Problem Description:

SMT component U5 QFN 20-pin is having insufficient solder volume at reflow.

QFN 20-Pin

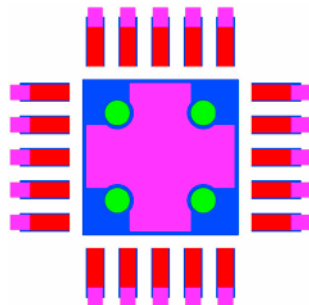
For leadless components, the terminal should cover 90%-100% of the SMT pad on the printed circuit board. On this assembly, the QFN covers 79% (terminal length is 0.0236" and SMT pad length is 0.0299") of the SMT pad. The root cause of the insufficient solder volume is a result of too much surface area for the solder to wet to with enough left over to form an acceptable solder joint.

On leadless components, solder will uniformly wet to the surfaces of the terminal and SMT pad. When the terminal is 90%-100% of the SMT pad, solder is shared between the two surfaces. When the SMT pad is longer than the terminal, it creates surface area that is not shared between the two surfaces. Solder will be pulled from the joint during reflow to cover the additional surface area and the result is insufficient solder volume at the terminal.

To eliminate the insufficient solder problems with the QFN component, the volume of solder printed must be increased, given the small leadless terminals and large, comparatively, SMT pads. Fine Line Stencil has developed proven formulas that calculate the required volume increase eliminate the insufficient solder volume problem without causing bridging. The recommended stencil aperture size is as follows:

QFN 20-pin: 0.009" x 0.0355" (10.5% volume increase)

To minimize voids in the thermal pad, the four vias are not pasted. Applying solder paste around, but not directly over, the open vias minimizes the amount of flux and solder that gets lost to the via barrels. Voids in thermal pads with open vias are common not due to trapped gases, but insufficient solder volume. Not printing directly over the vias retains more of the solder volume for the joint between the PCB and component thermal pads.

0603 and 0805 Chips

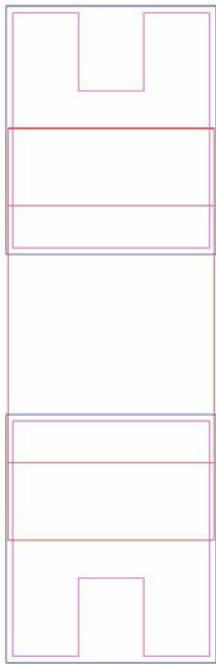
The 0603 and 0805 land pads are too far apart for the sizes of the chip packages. Any shift at pick-and-place can cause tombstone problems at reflow. To eliminate the tombstone potential, solder paste was removed from the back end of the chips. This will lower the wetting strength at the ends of the terminals and reduce the downward pull on the chip terminals. When one terminal has a much larger downward pull, due to more solder paste wetting to the terminal, the chip can be tipped onto its end causing it to tombstone.
